Access Compliance Report

Public Rights-of-Way

Main Street: RED_HILL_AVE Cross Street: KENNETH_DR Location: NW

ADA ID: RPAT211021143127 Ramp Type: Type 3 - Combination 1 Initial Pass/Fail: Fail Overall Compliance: No Severity Score: 16

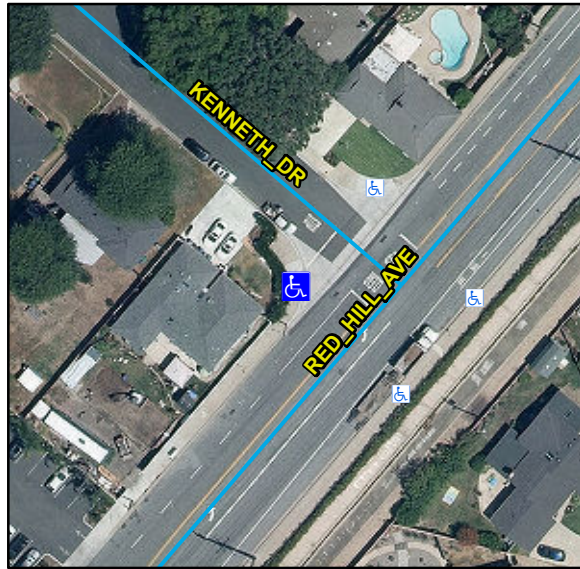
Compliance	Description	Data	Compliance	Description	Data
N/A	Ramp Length LT (in)	89	N/A	Ramp Length RT (in)	80
Yes	Ramp Width LT (in)	50	Yes	Ramp Width RT (in)	53
Yes	Ramp Run Slope LT (%)	4.6	No	Ramp Run Slope RT (%)	10.1
No	Ramp Cross Slope LT (%)	2.3	Yes	Ramp Cross Slope RT (%)	0.2
N/A	Ramp Length (in)	50	N/A	Flare Type LT	
Yes	Ramp Width (in)	49			N/A
Yes	Ramp Run Slope (%)	6.7	N/A	Flare Slope LT (%)	N/A
Yes	Ramp Cross Slope (%)	1.7	N/A	Flare Traversable LT	N/A
N/A	Landing Present	N/A	N/A	Flare Type RT	
N/A	Landing Length (in)	N/A			N/A
N/A	Landing Width (in)	N/A	N/A	Flare Slope RT (%)	N/A
N/A	Landing Run Slope (%)	N/A	N/A	Flare Traversable RT	N/A
N/A	Landing Cross Slope (%)	N/A	N/A	DWS Provided	N/A
N/A	Landing Movement Obstructed?	N/A	N/A	DWS Contrast	N/A
	Landing Movement Type	N/A	N/A	DWS Length (in)	N/A
N/A	Landing Shared	N/A	N/A	DWS Full Width	N/A
N/A	Clear Space	Yes		DWS Offset Type	N/A
N/A	Clear Space To Crosswalk (in)	N/A	N/A	DWS Offset Left (in)	N/A

Remove & Replace Curb Ramp With Two New Directional Ramps or Equivalent. Remove & Replace Sidewalk.
